# 7 and 33 Princes Highway, Dandenong South

Planning permit  
no.PA2403037

Officer Assessment Report  
Development Approvals & Design

Department  
of Transport  
and Planning

Figure 9: Street Tree Protection Zones impacted by proposed left-turn lane shown shaded in blue

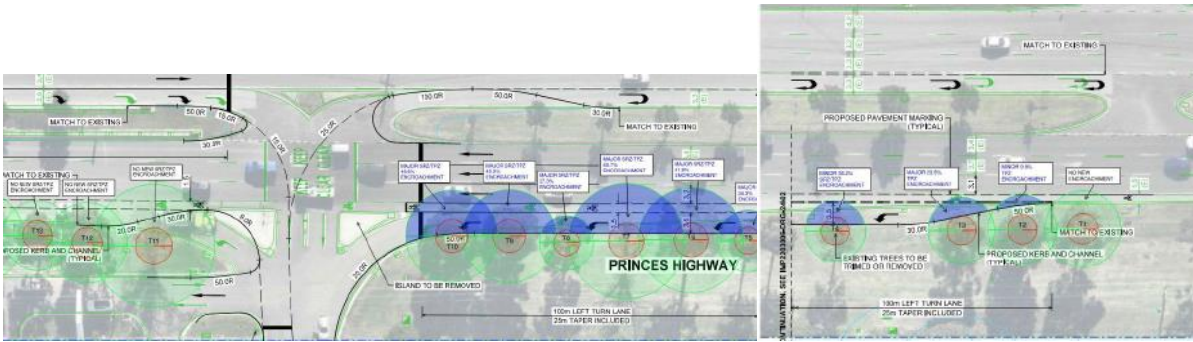
22. TfV requested a revised Traffic Impact Assessment Report in a second RFI 20 November 2024.
23. Greater Dandenong City Council also responded 27 November 2024, raising concerns with the impacts on street trees that would result from an extension of the left-hand turn lane into the site. A meeting between DTP and Council officers confirmed the council's opposition to any street tree removal. Street trees that would be impacted by the left-turn lane are shown in Figure 9 on the following page.

24. An option to relocate the current on-road bicycle lane was discussed and a concept plan provided by the applicant, as well as an updated arborist report, on 16 December 2024 which advises this option would avoid removal of the street trees. The bicycle lane would be replaced with an off-road shared path. This option was supported by Transport for Victoria in their referral response 17 December 2024. The council has also indicated moving the bicycle lane could be a potential solution, subject to arborist assessment.

25. It is therefore considered the proposed roadworks can be supported, subject to the plans being amended in accordance with the concept intersection plans.

Figure 10: Concept design for intersection, showing on-road bicycle lane relocated and proposed left-turn lane located further north of street trees

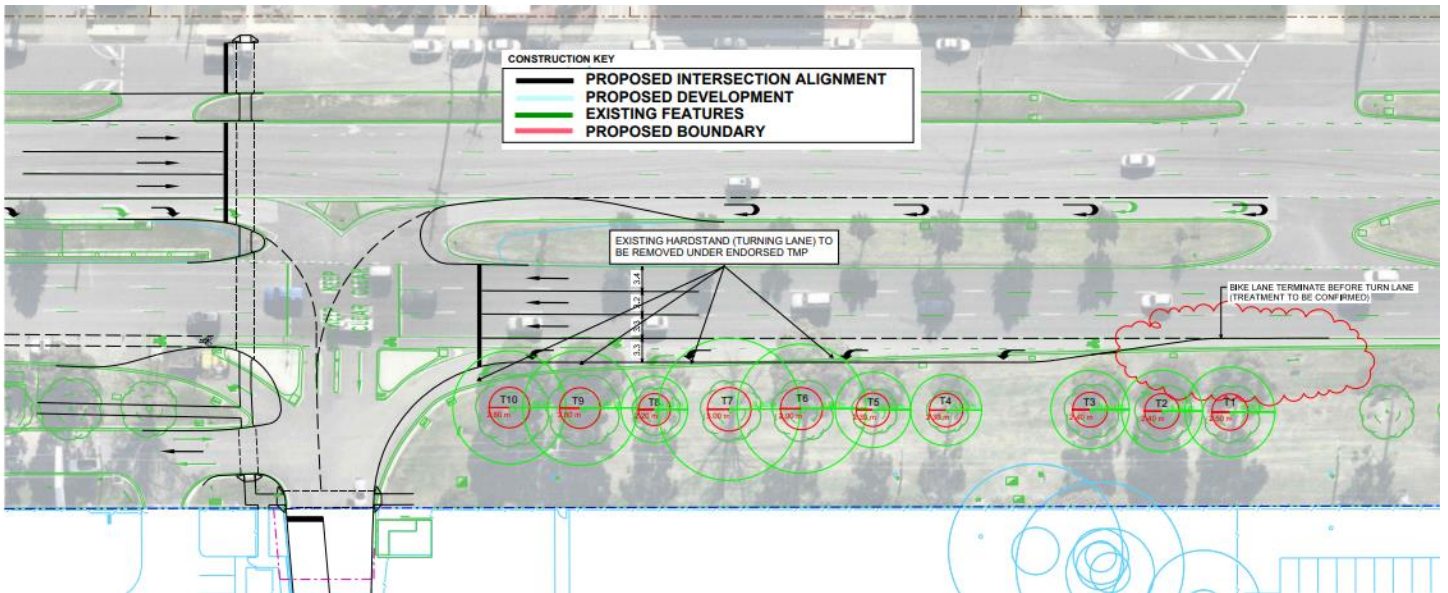
19. A technical note and Safe System Assessment by Impact Traffic Engineering were submitted in late September and early October 2024 in response to the RFI. This was followed by a meeting with the applicant, Transport for Victoria and DTP planning officers on 9 October, during which concerns were expressed by TFV regarding the approach taken in the further traffic engineering work – chiefly regarding the proposed use of an unsignalised 'seagull' intersection to provide access to the site from Princes Highway.

20. TfV completed their review of the further information following the meeting, and verbally advised the proposal would not be supported in its current form due to the unresolved traffic concerns. Rather than await a written objection from TfV, the applicant elected to provide a signalised option, which TfV indicated was a better approach to the concerns raised.

64. The proposed access shown in Figure 10 earlier has been considered by Transport for Victoria and is regarded as appropriate. A condition of permit will require the plans to be amended to show this design.
65. The proposed 10m wide internal accessway has been designed to accommodate the movement of B-double trucks within the site for Warehouses 3, 4 and 5, including a court bowl to provide sufficient turning area. Swept path diagrams have been provided demonstrating sufficient access using the internal accessway and loading areas.
